ALLEGHENY COUNTY SANITARY AUTHORITY

CONTRACT NO. 1759 G, E, H, P

ENVIRONMENTAL COMPLIANCE FACILITY

ADDENDUM NO. 4

ALLEGHENY COUNTY SANITARY AUTHORITY
WASTEWATER TREATMENT PLANT
ALCOSAN ENVIRONMENTAL COMPLIANCE FACILITY
000-PSP-01
PLUMBING UTILITY SITE PLAN

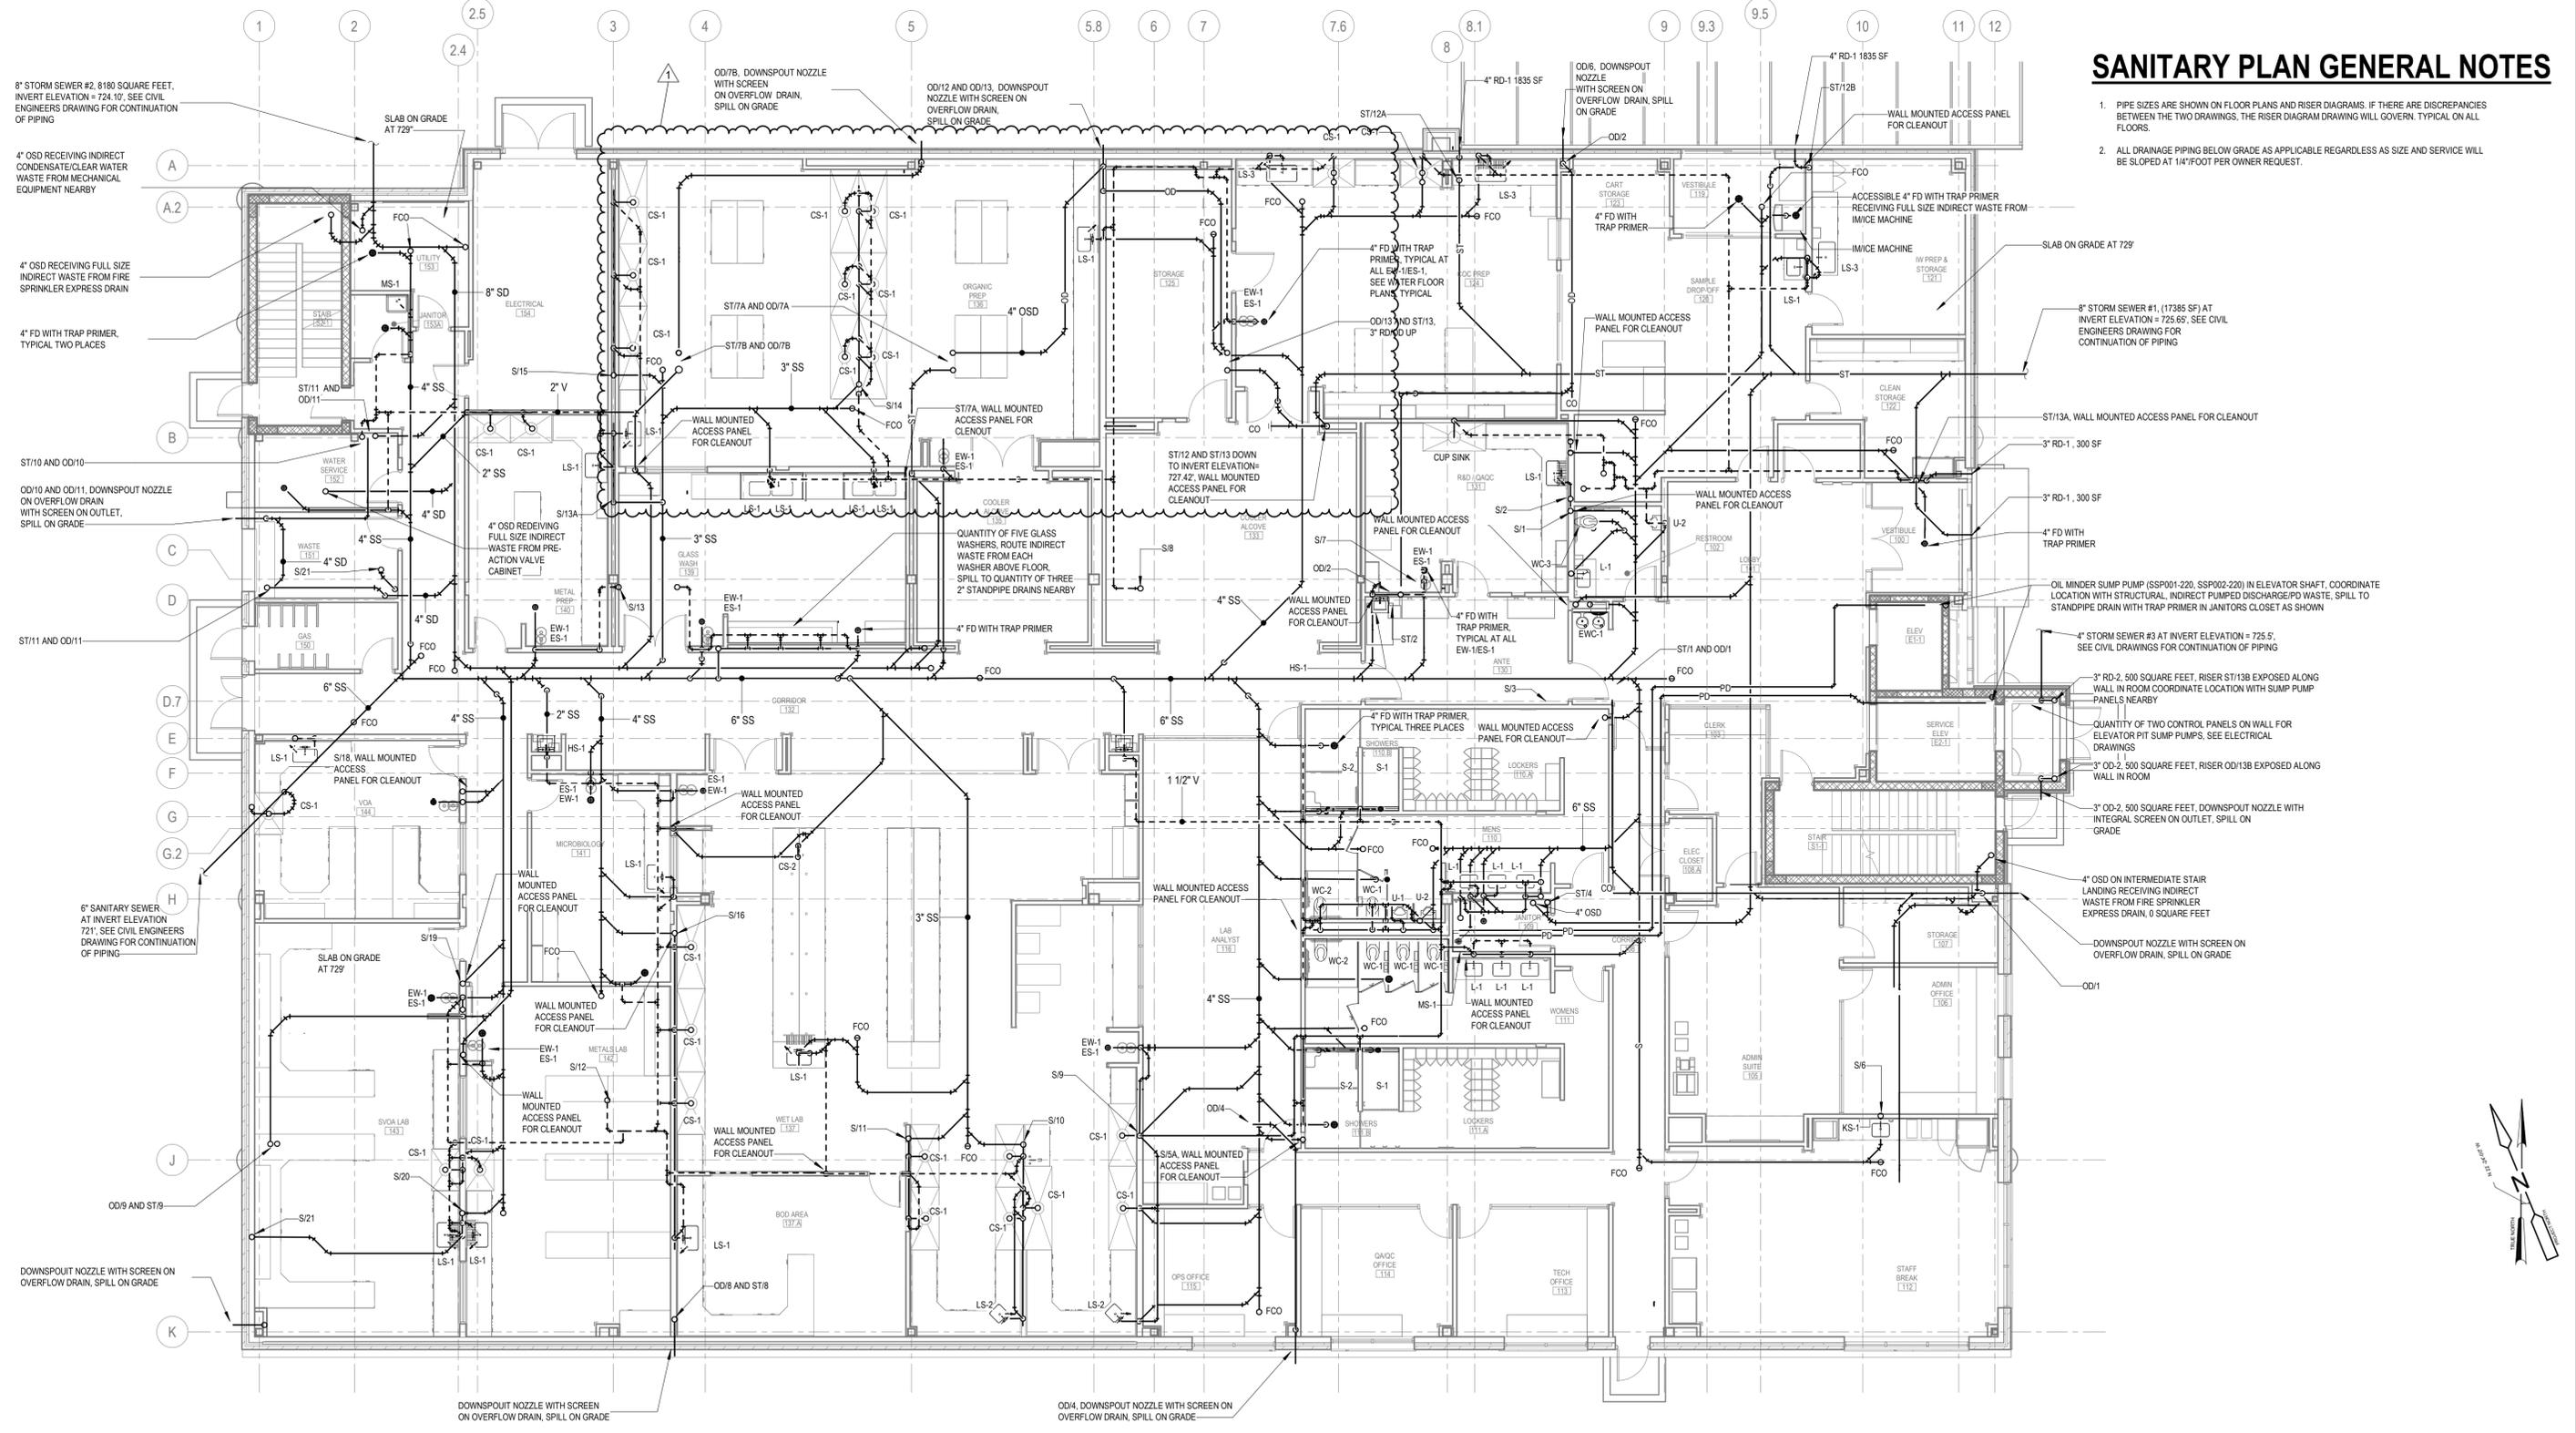
- b. Revised ceiling material types.
20. Drawing 000-PSP-01 Plumbing Site Plan
 - a. Notes updated in clouded area regarding plumbing contractor being responsible for gas piping connections to source.

ALLEGHENY COUNTY SANITARY AUTHORITY
 WASTEWATER TREATMENT PLANT
 ALCOSEN ENVIRONMENTAL COMPLIANCE FACILITY
220-P-30
GAS PLAN - FIRST FLOOR

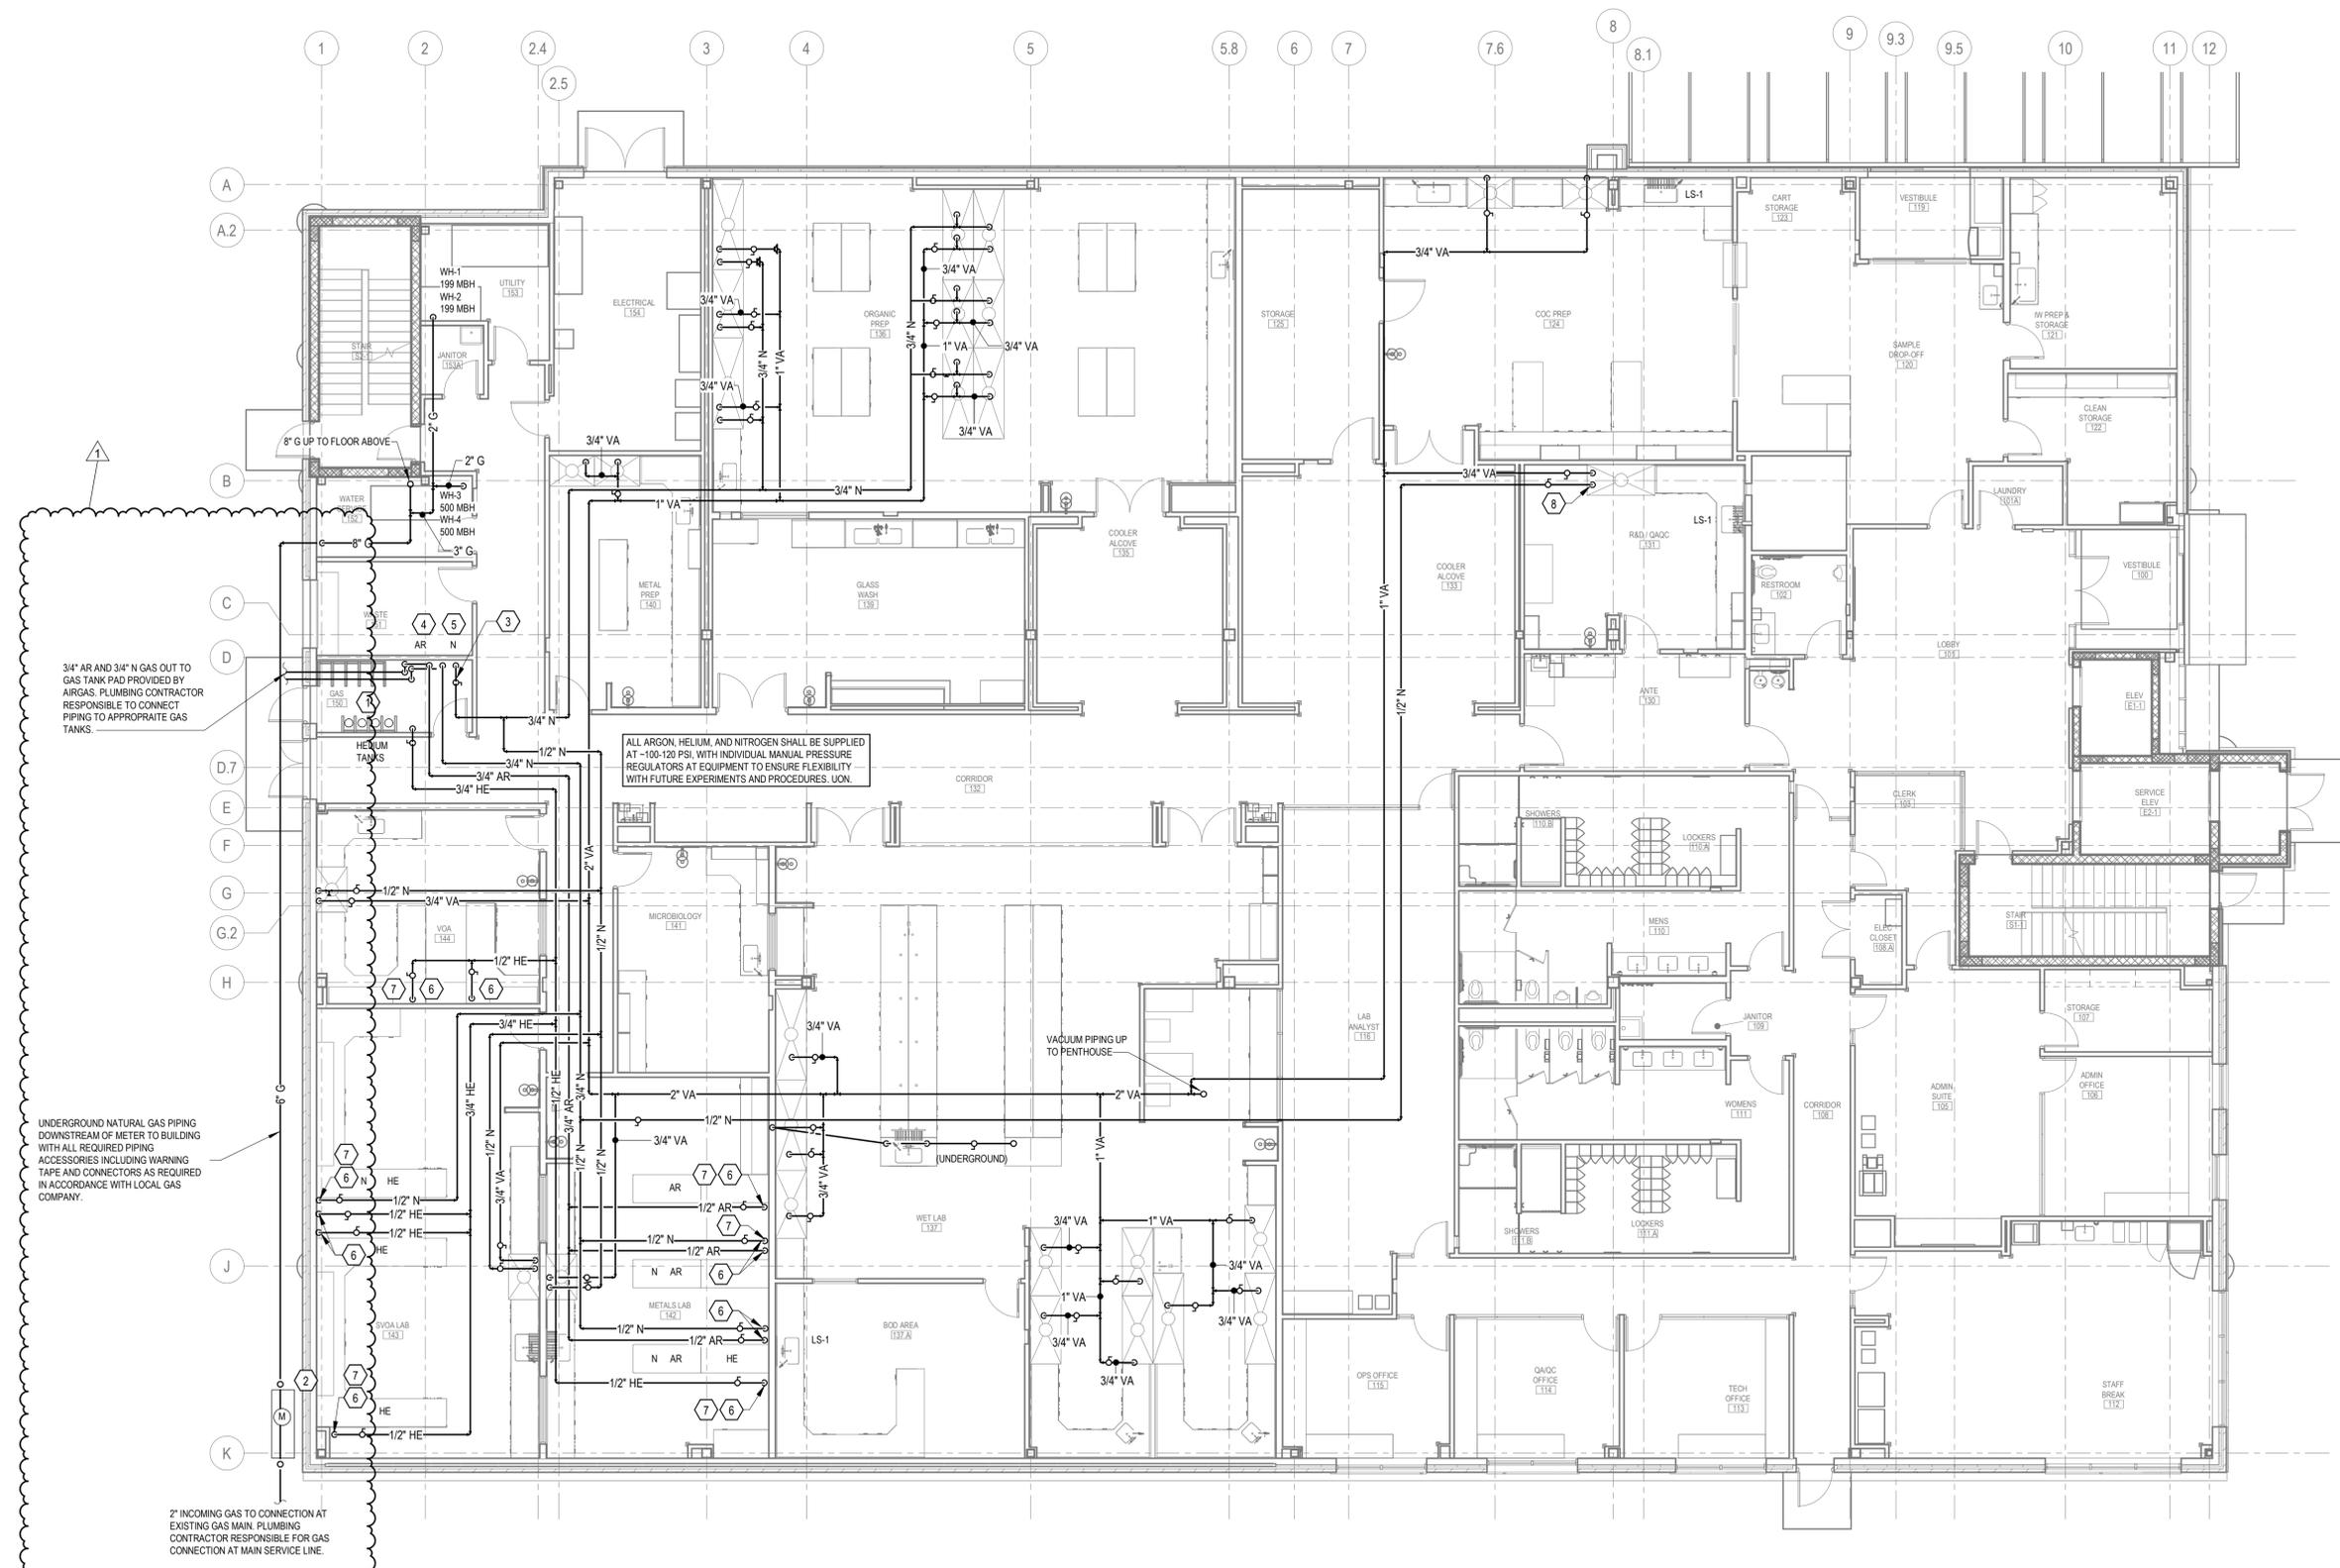
22. Drawing 220-P-30 Gas Plan First Floor
 - a. Notes updated to reflect plumbing contractor responsible for gas piping from, building to source. See clouded area for changes.

A20: The plumbing contractor will install the total routing of the piping with all required accessories and final connection to the tanks. Plumbing drawing 220-P-30 is updated with notes stating plumbing contractor scope of work.

220-H-10C
HVAC PLAN - PARTIAL FIRST FLOOR - SECTION C

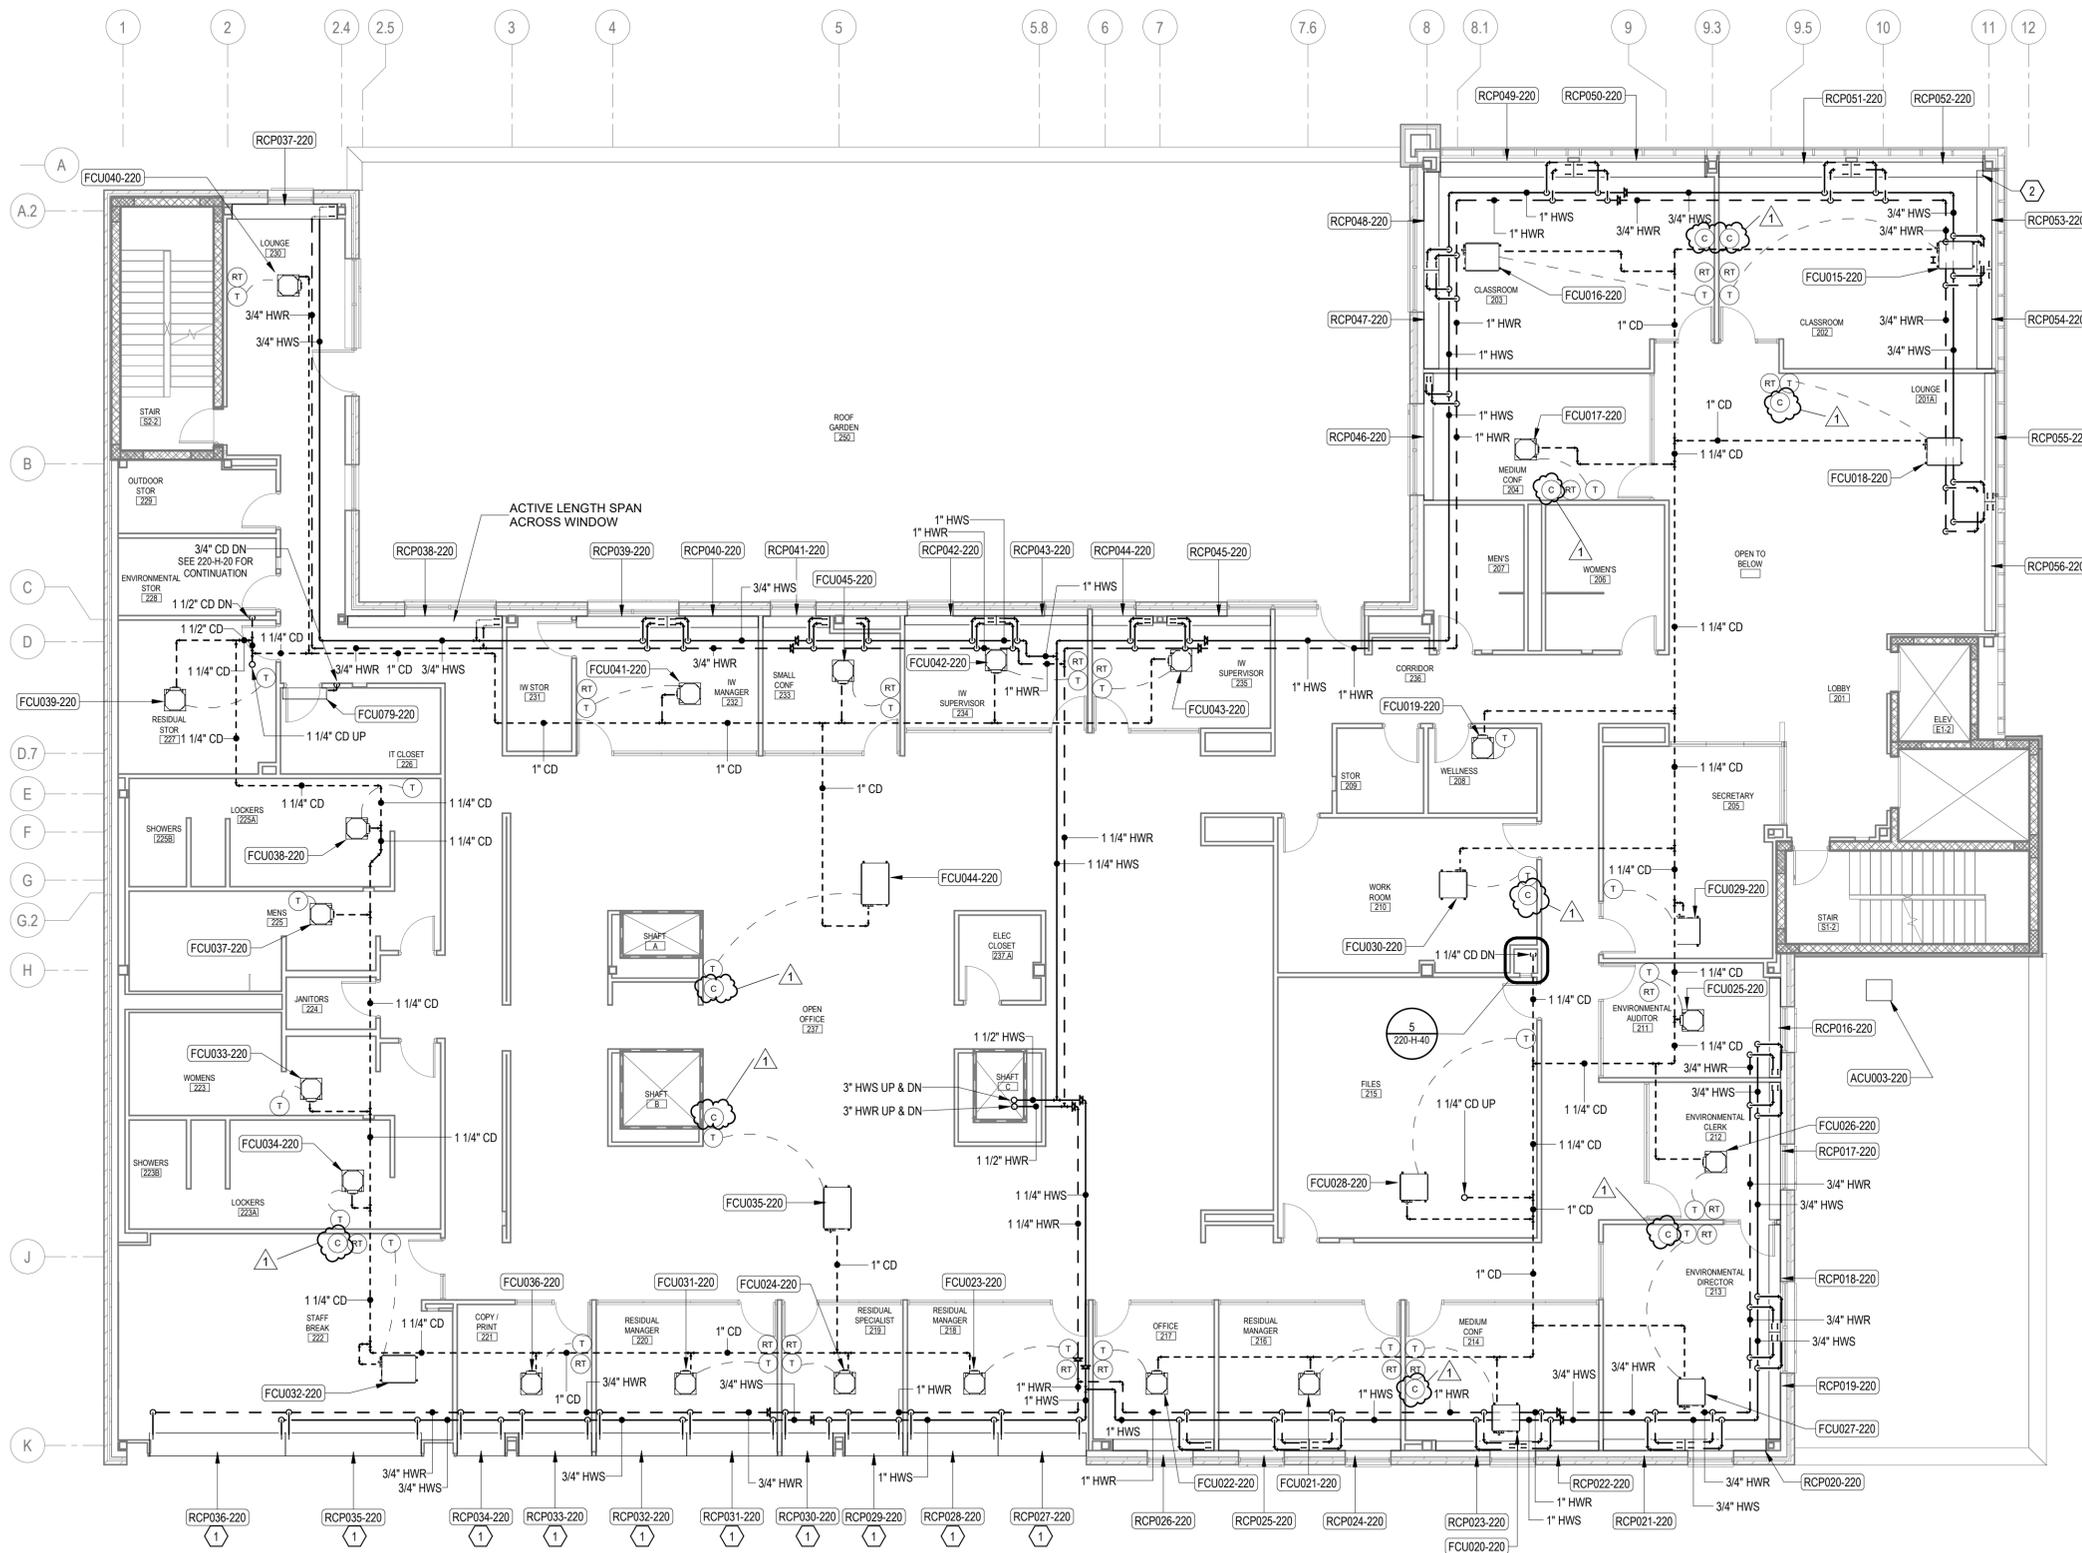
- a. Revised keynote 3 to provide exhaust snorkel designation.
25. Drawing 220-H-10C – HVAC Plan – Patrial First Floor – Section C
 - a. Revised keynote 3 to provide exhaust snorkel designation
